DRAWING AMENDMENTS

REMARKS

The Office Action mailed 06/14/2005 states that:

FIG. 1

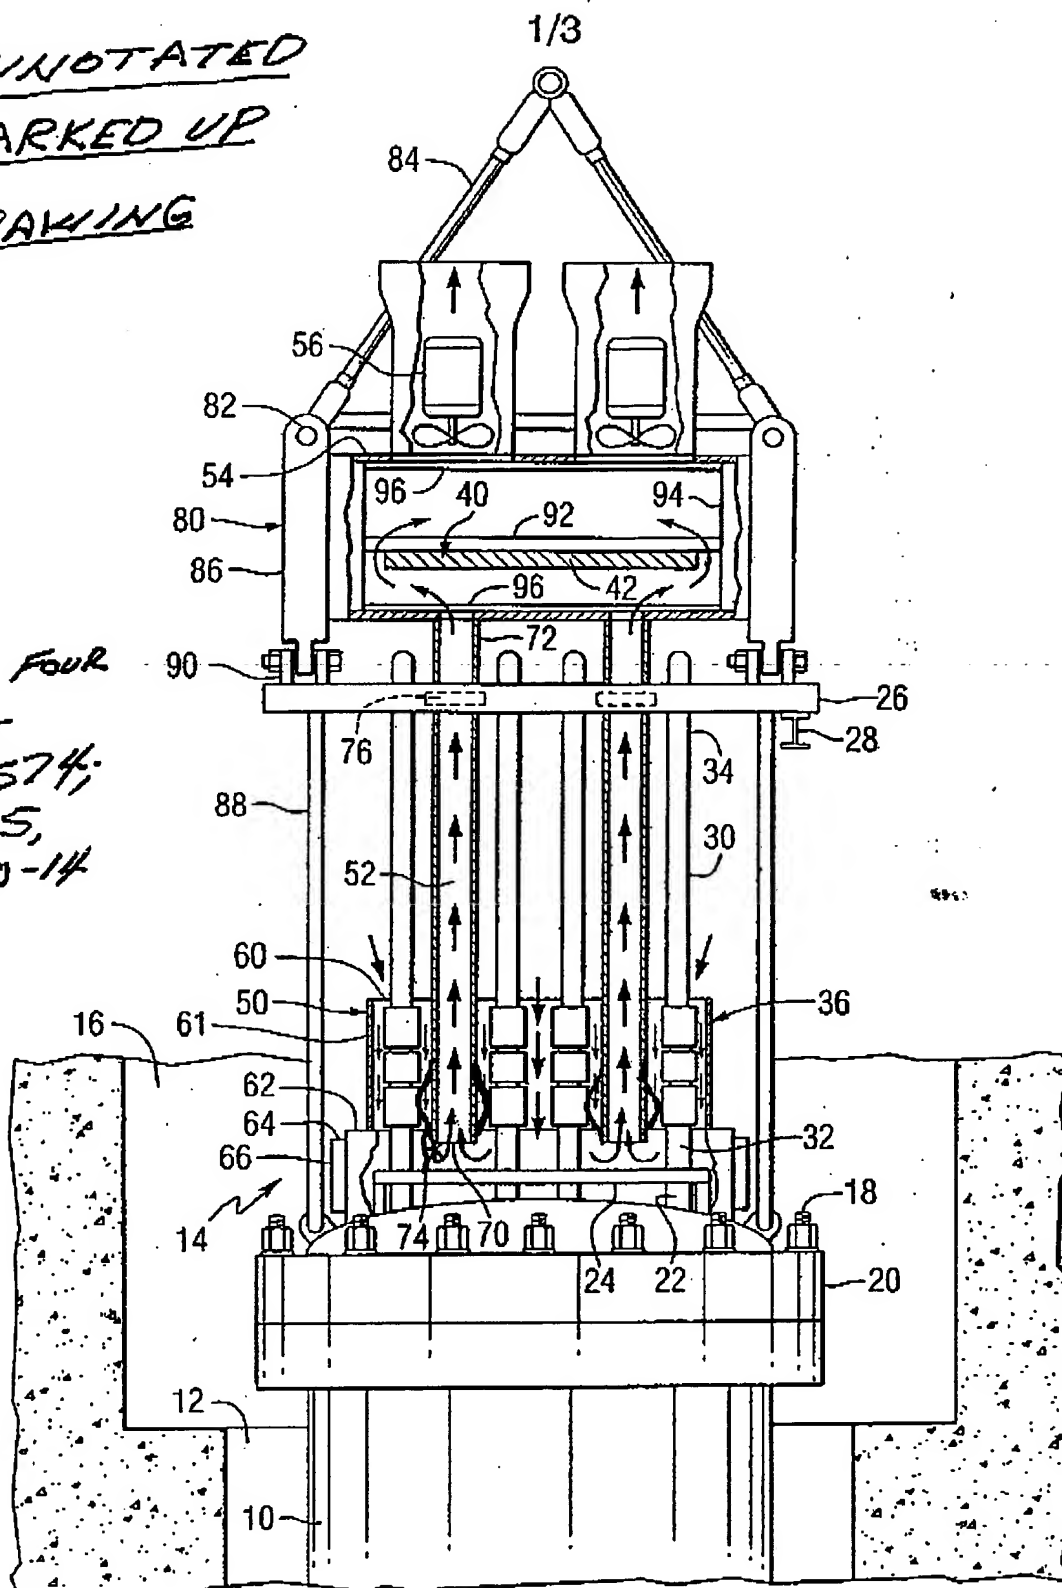
The Examiner pointed out that the drawings do not show the "resilient spring 74" described in the description at page 5, lines 10-12, as "a narrow deformed length of the internal duct 52" which supports the lower end 70 of the duct 52 against the coil stack assemblies 36.

ADDED FOUR
RESILIENT
SPRINGS 74;
SEE PAGES
5, LINES 10-14

Please replace the current Figures 1 and 3 (that were examined 6/14/2005) with the following Replacement Figures 1 and 3. These drawing figures have been amended at four locations to indicate "springs 74" at the lower ends of "internal ducts 52". An explanation of the changes is incorporated into the following Remarks section of this Reply. A marked up copy of current drawing Figures 1 and 3 indicating the changes is attached to this Reply as Appendix A.

The Applicants have amended Figures 1 and 3 to show the lower ends of ducts 52 having deformed lengths or springs 74 (as recited by Claim 2) supported by adjacent coil stack assemblies 36 (as recited by Claim 3).

FIG. 4

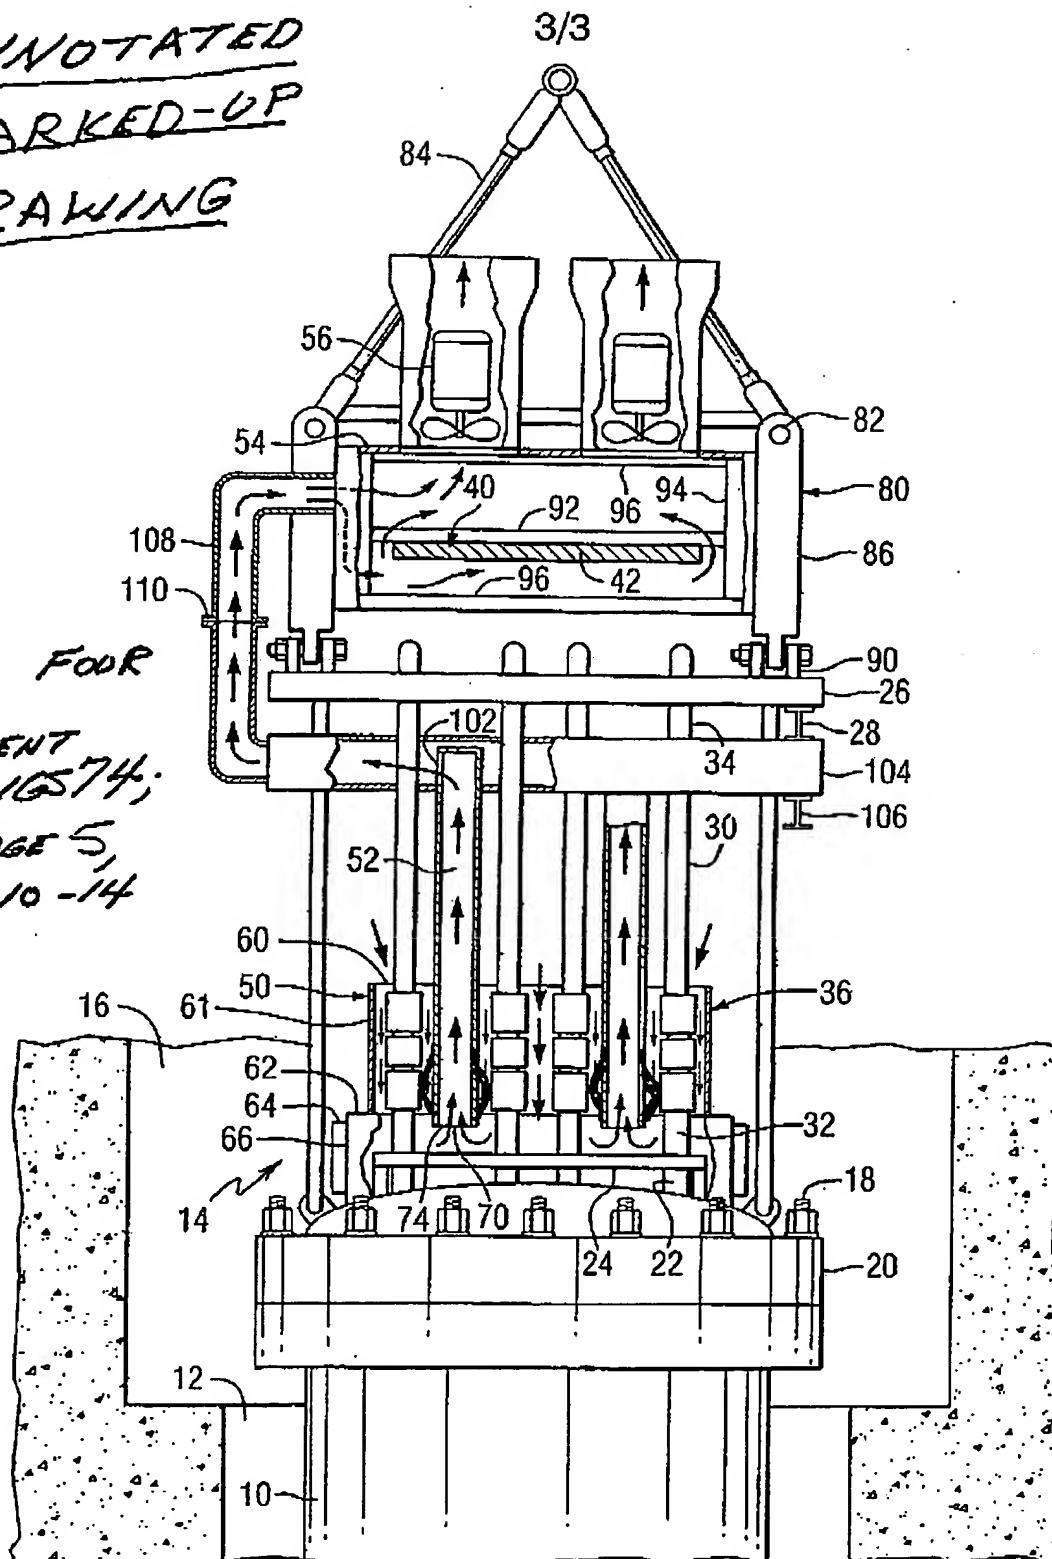
ADDED FOUR
RESILIENT
SPRINGS 74;
SEE PAGE 5,
LINES 10-14
